BNP-2011-071

PPL Response to SRBC Letter Dated January 19, 2011

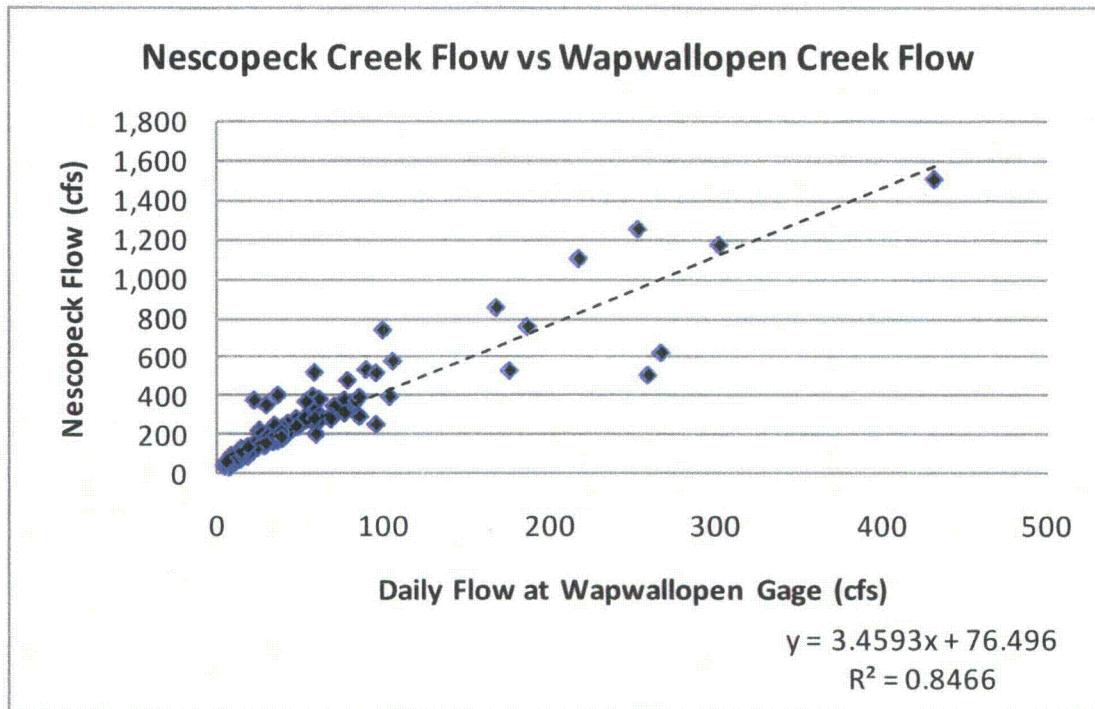
Section 3.1.1 states that, "Flow in the river between Nescopeck Creek and Fishing Creek will be assumed to be the sum of the Wilkes-Barre flow and the Nescopeck flow." The method to simulate flow needs to be further clarified. The stated method does not take into consideration: (1) the drainage in between the Wilkes-Barre gage and the Nescopeck Creek confluence with the Susquehanna River, which includes numerous tributaries to the Susquehanna River (including the U.S. Geological Survey [USGS]-gaged Wapwallopen Creek); (2) how flow will be simulated from a non-realtime Nescopeck Creek USGS gage; and (3) what flow will be simulated from the Nescopeck Creek USGS gage.

In Section 7 ("Water Quality Assessment of Nescopeck AMD Discharges"), we will document derivation of the proposed method for estimating the Nescopeck Creek flow for the days or time periods for which an estimated Nescopeck flow is necessary. This documentation will be presented in a separate subsection entitled "Estimating Nescopeck Creek Flows." The proposed method will be to correlate Nesopeck daily flow to daily flow gaged by USGS in the Wapwallopen Creek at Wapwallopen as follows:

$$\text{Nesopeck flow (cfs)} = [3.46 * \text{Wapwallopen flow (cfs)}] + 76.5 \text{ cfs}$$

Determination of the proposed correlation makes use of the approximately 140 Nesopeck Creek flows observed since 1949, as shown in the figure, below.
